# My Submission to Northern Beaches Council

Attention: Thomas Burns Planner Re: Mod2020/0715 - DA2018/0612  
7 Pavilion Street, Queenscliff

Mod 2020/0715 Nolan Planning

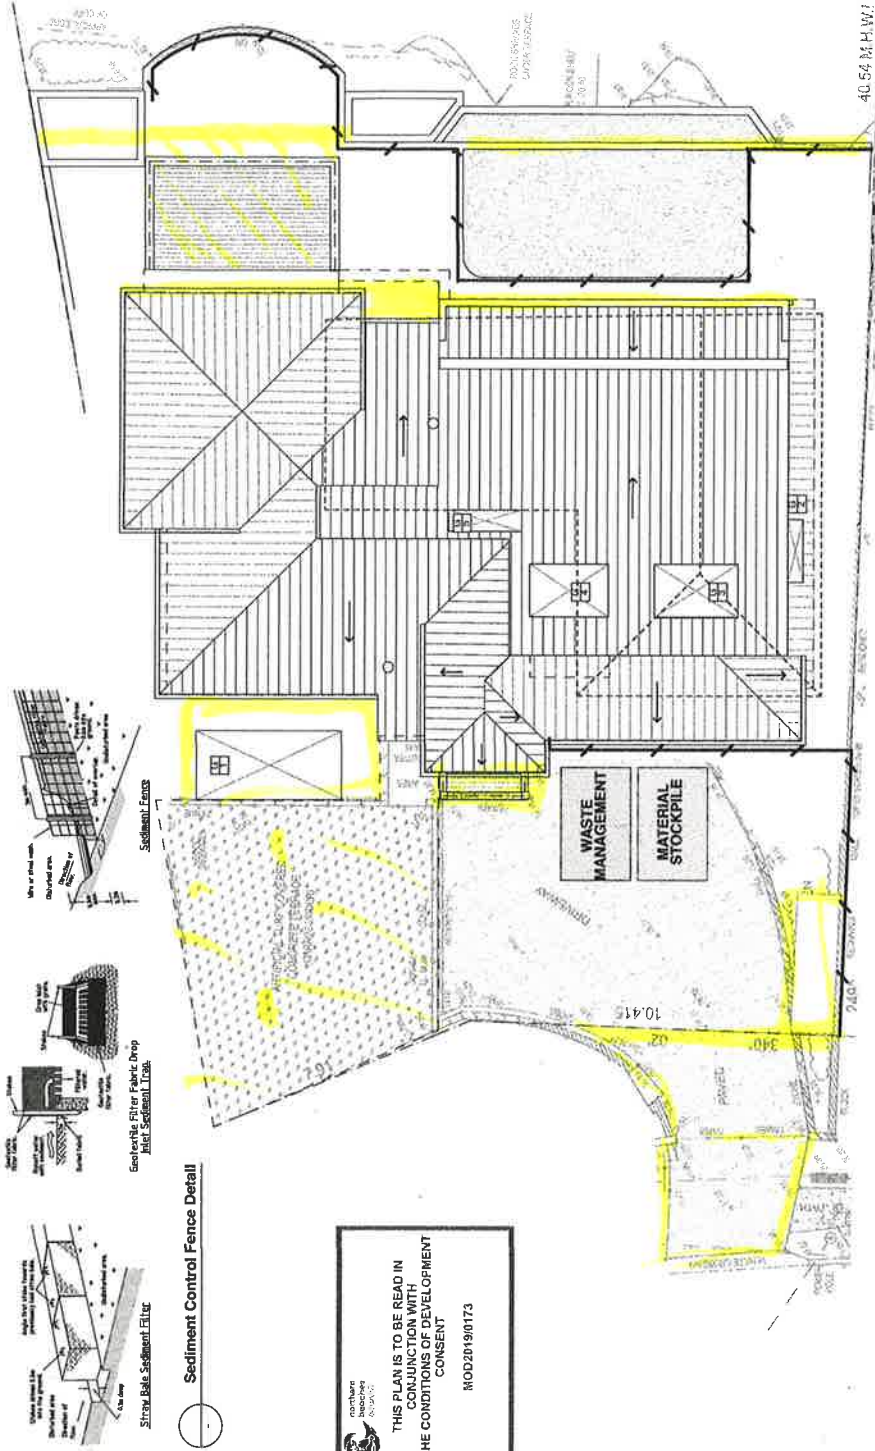
With regard to the Nolan Planning diagram in this MOD2020/0715, the 2 highlighted areas are not correctly drawn, as the roof and gutter were built (IMG 5110), and later a new scaffold was constructed to add the box like ceiling structure that now exists built out to the East from that gutter, IMG 5264 taken 18/5/20.

I would like the box like structure added to the N/E gutter to be removed as it was never in the approvals. It is drawn inaccurately in Nolan Planning's diagram in this Mod, when in fact the box is built out 400mm approx. to the east from the gutter. This box sits in our view from our bedroom. I request that the Pagola/Operable Roof be set back 1 metre from the current temporary position of the 2 posts (and temporary roof) and be rebuilt as scaled in the approved drawings. I question the cliff setback compliance of this structure?

Lvl 2 Balcony Extended 250mm approx beyond wall below - IMG 6624

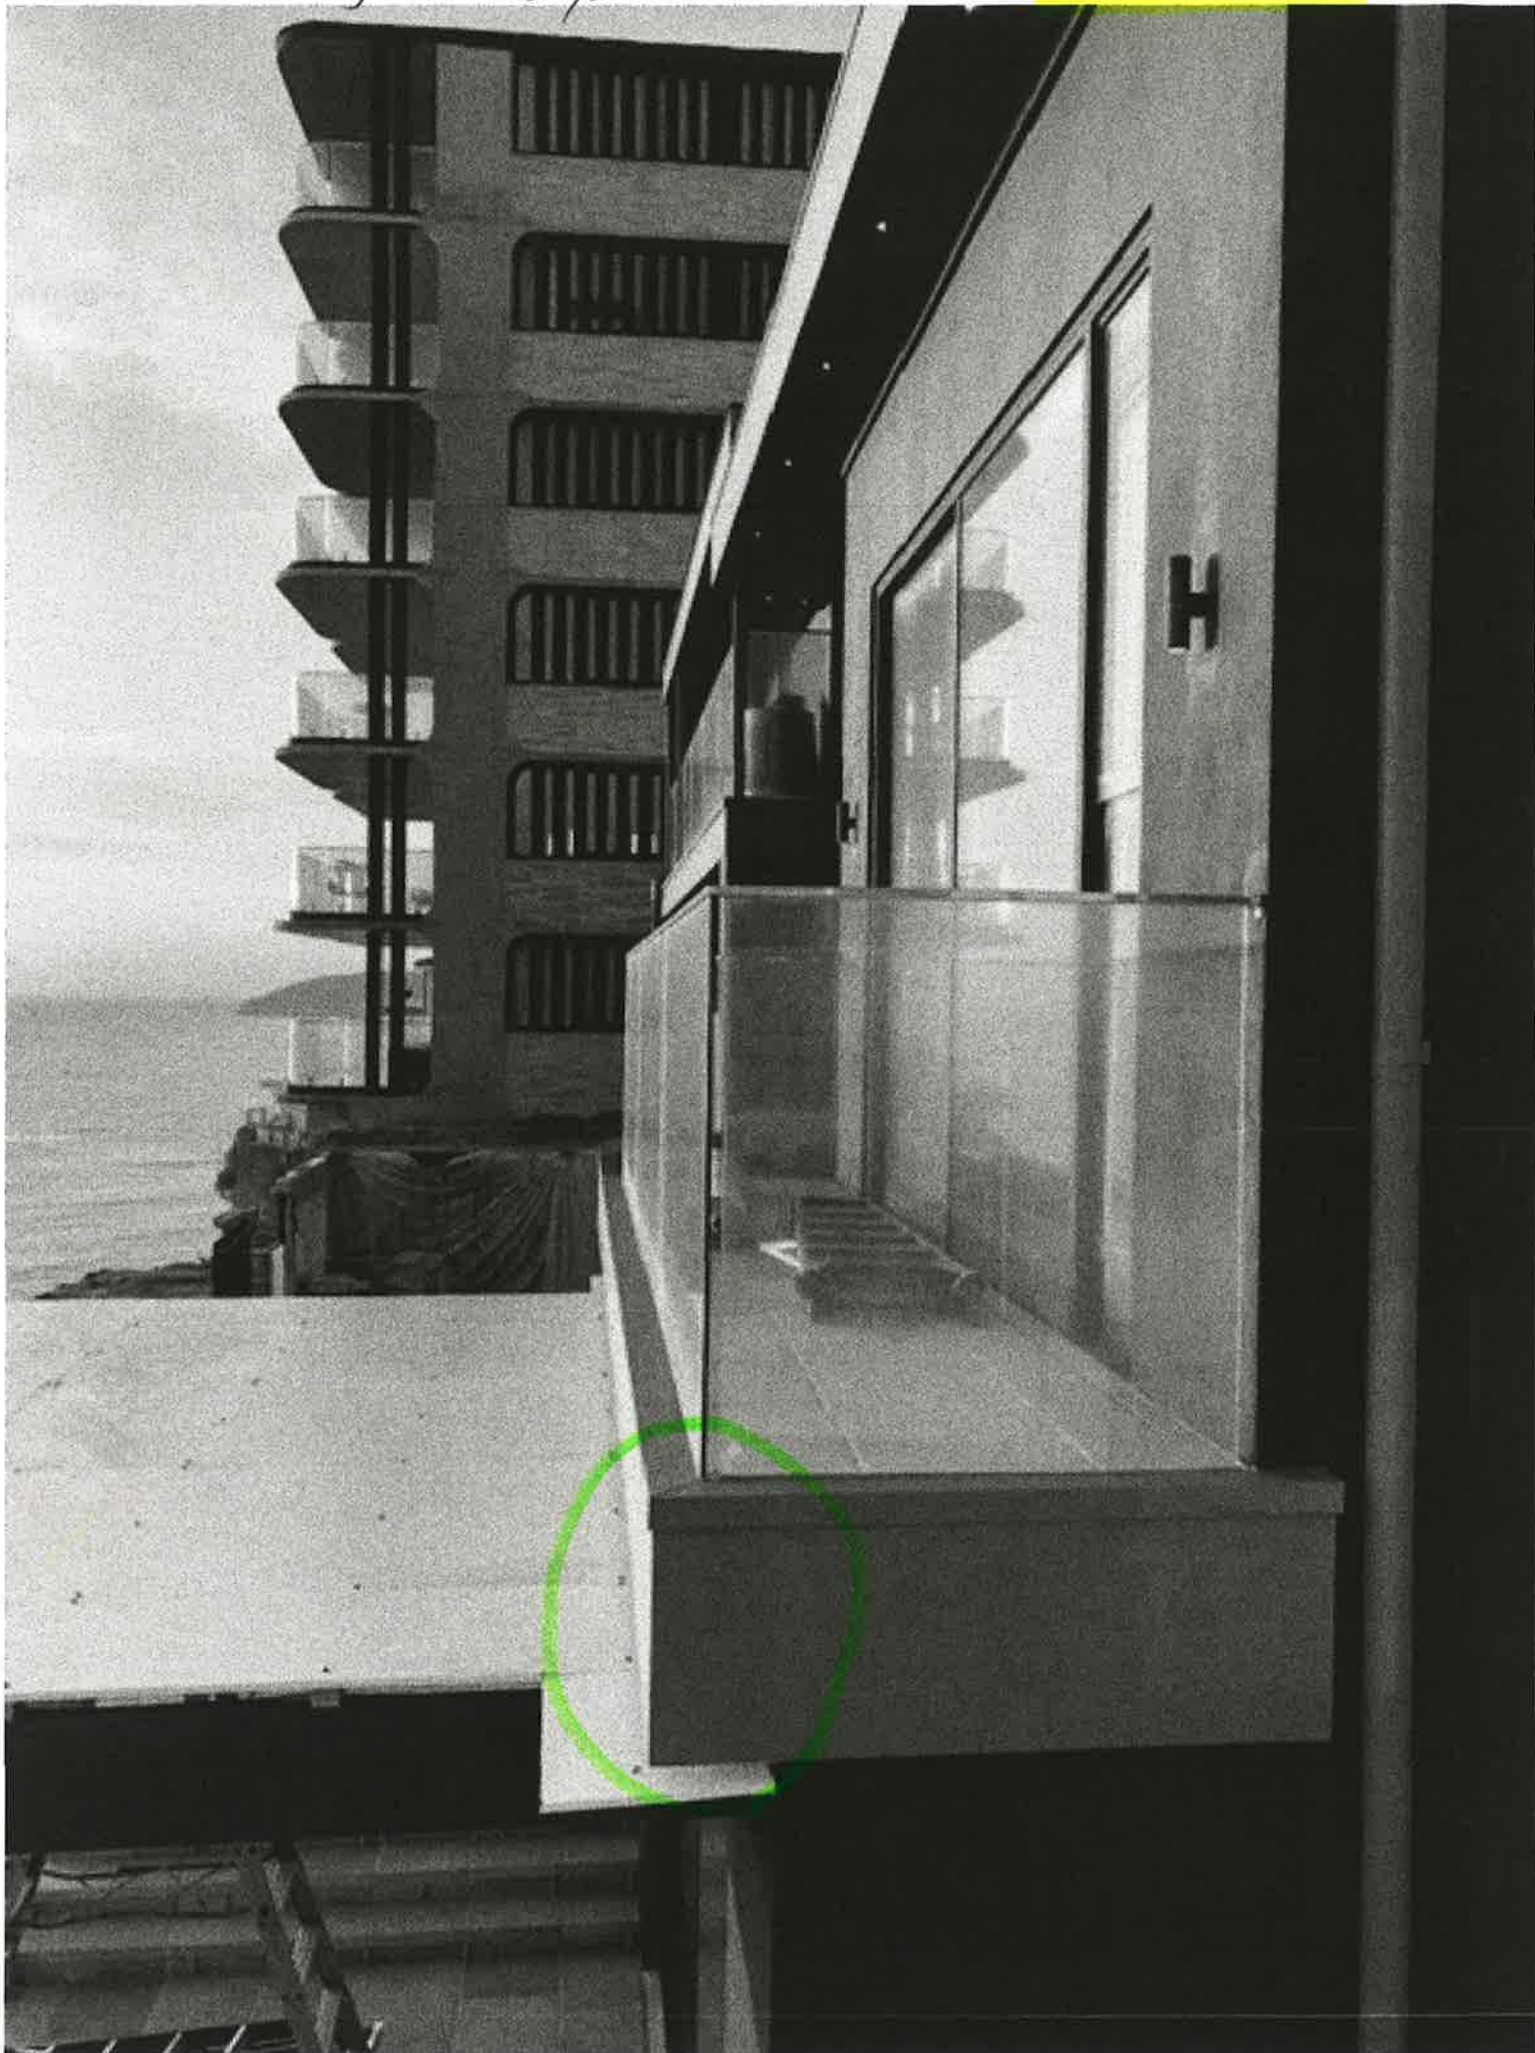
There are many changes and extensions along the cliff front façade that do not agree with the approved drawing DA03 in MOD 0173 and the current MOD 0715.

Extension of Lvl 2 Bakery, Courtyard, Steps & Pagoda to cliff 1MA6529 Nov 20

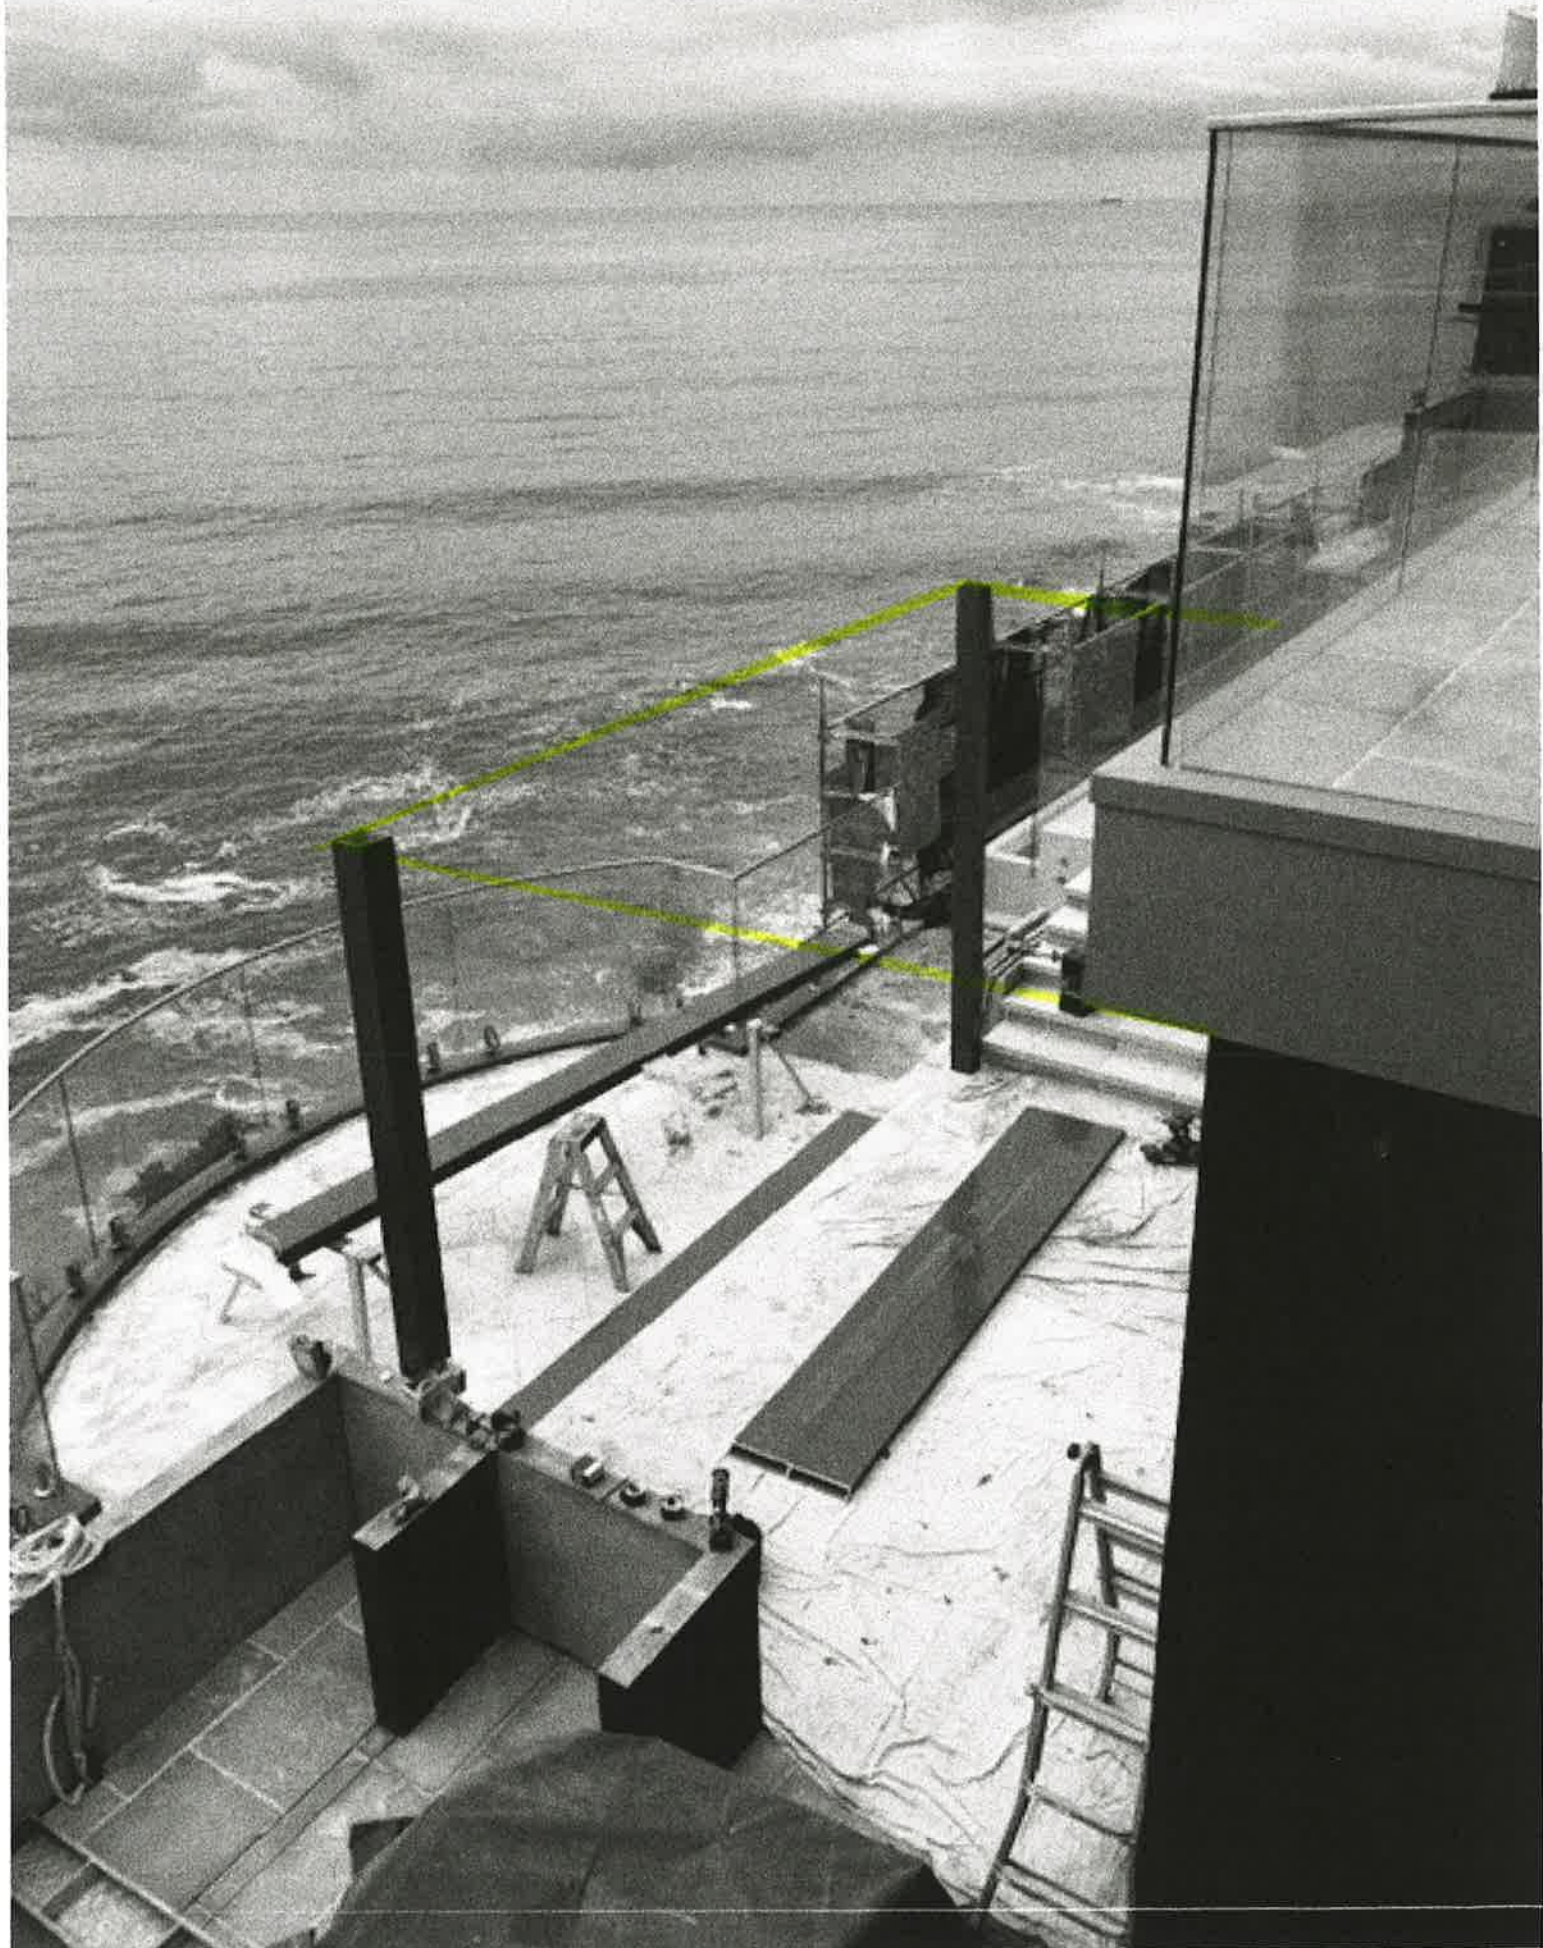
IMG 5496 & 6529 show the rebuilding of the steps down to the circular balcony area which have moved closer to the cliff edge and the construction of the new outdoor kitchen larger and closer to the cliff edge. The positioning of the pagola posts closer to the cliff and taller than originally, which sit directly in our living room views. The approved plans state "replace existing pergola" and MOD 0173 calls it an 'operable roof'. This pagola is not built to scale as per the approval.
